Subject: Inspecting trim indicator and reinforcing bowden cable flexible steel hose.

ASK 21
Technical Note
No. 18

Alexander Schleicher
Segelflugzeugbau
6416 Poppenhausen

Datum	Name	Typ	Benennung	Maßst.
				Bearb. 12.07.85	Jūw	ASK 21	Trimmanzeige TM-Nr. 18	1:2,5
				Geprü.				
				Norm				
A. Schleicher Segelflugzeugbau 6416 Poppenhausen						Zeichnungsnummer L-339 210.49.S 4		Blatt 1 2 Bl.
Zust.	Änderung	Datum	Na.	Urspr.	Ers. f.	Ers. d.

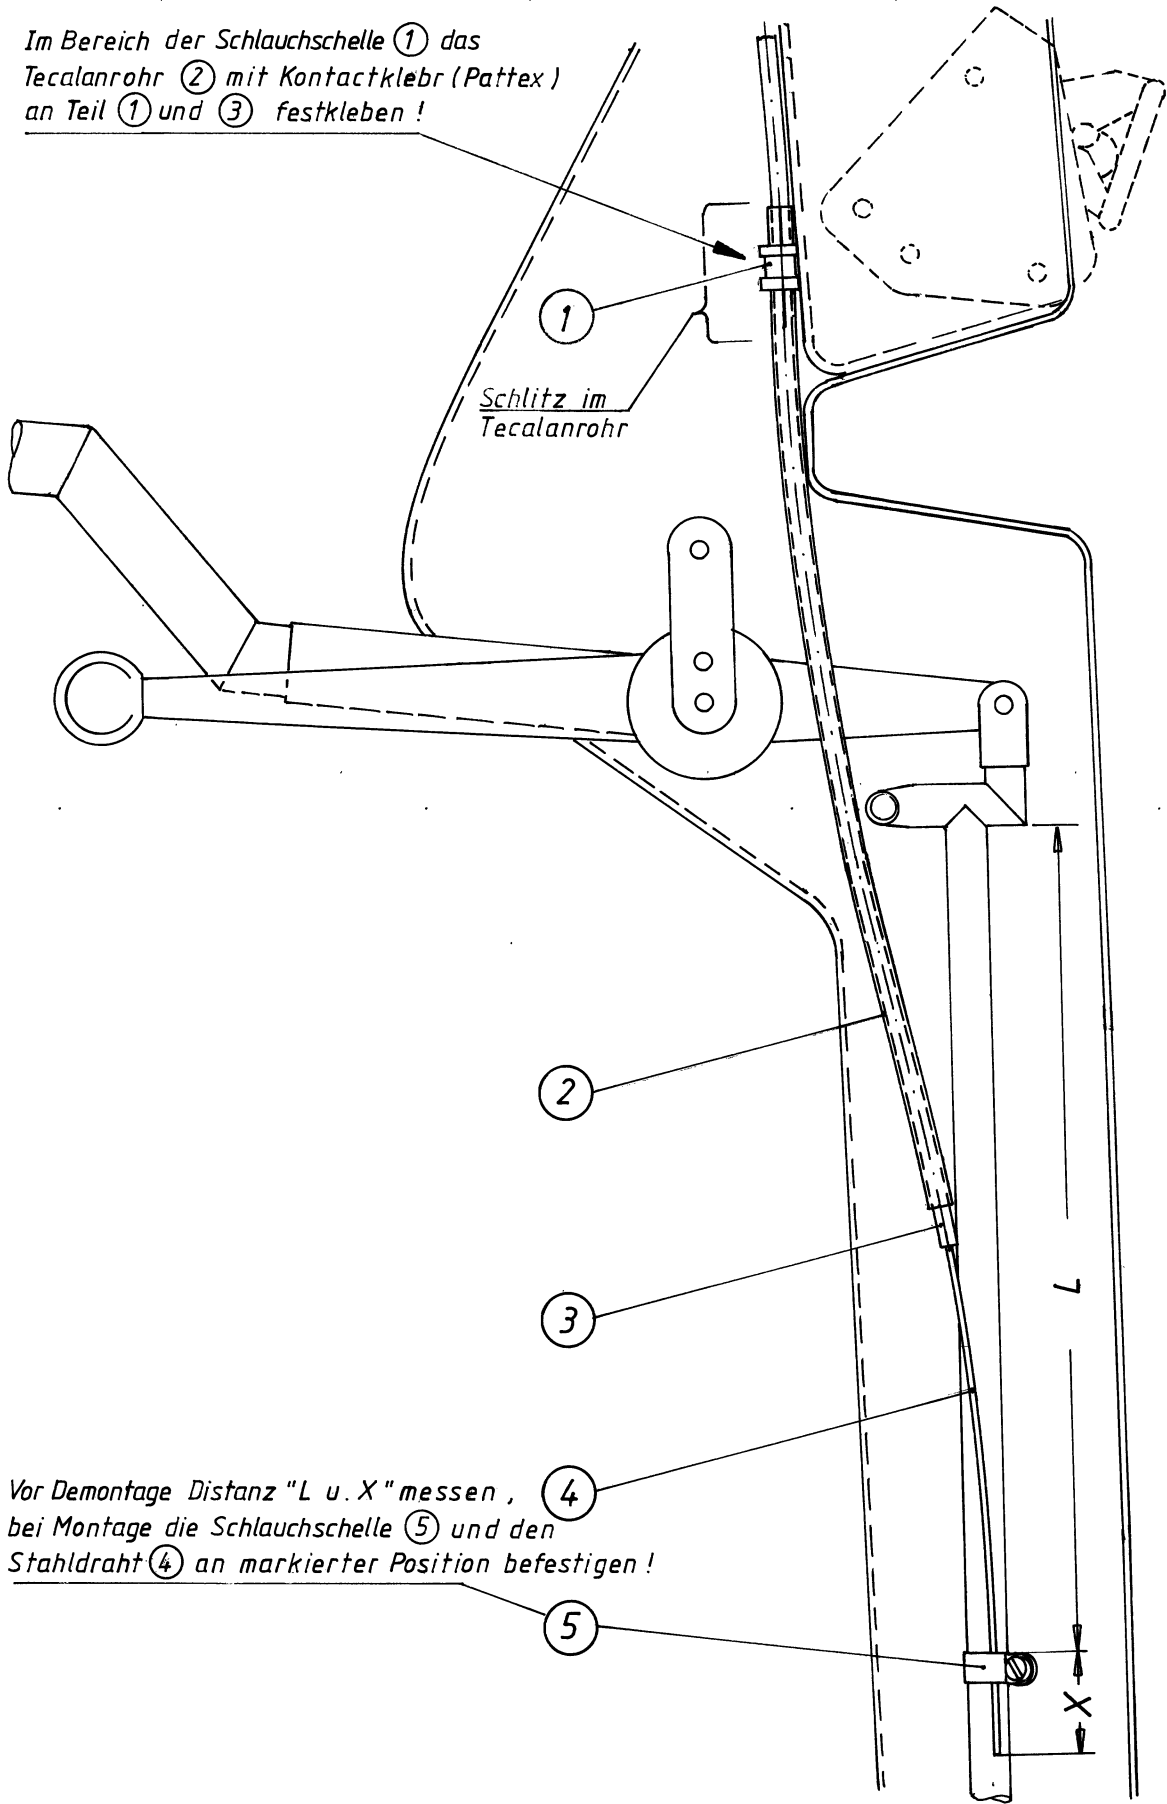
Reason: In some ASK 21s the trim indicator bowden cable at the rear control stick has been jammed between the control shaft and the aileron stop. This results in a slightly smaller stick deflection over to the right and it is possible that the trim indicator fails. This can happen only when the steel wire ④ can no more move clear in the bowden cable's flexible steel hose ③, e.g. owing to fouling and deficient maintenance; see drawing 210.49.S4

3. Mark the positions of the hose clamp ⑤ and of the steel wire ④. Then slip the Tecalan-tube ② over the bowden cable steel hose ③ as shown in drawing 210.49.S4. Now glue the tube in the area of the hose clamp ① to the parts ③ and ①, using contact glue, e.g. Pattex. Finally refix the steel wire ④ with the hose clamp ⑤ to their marked positions.

Im Bereich der Schlauchschelle ① das Tecalanrohr ② mit Contactklebr (Pattex) an Teil ① und ③ festkleben!

Vor Demontage Distanz "L u. X" messen, bei Montage die Schlauchschelle ⑤ und den Stahldraht ④ an markierter Position befestigen!
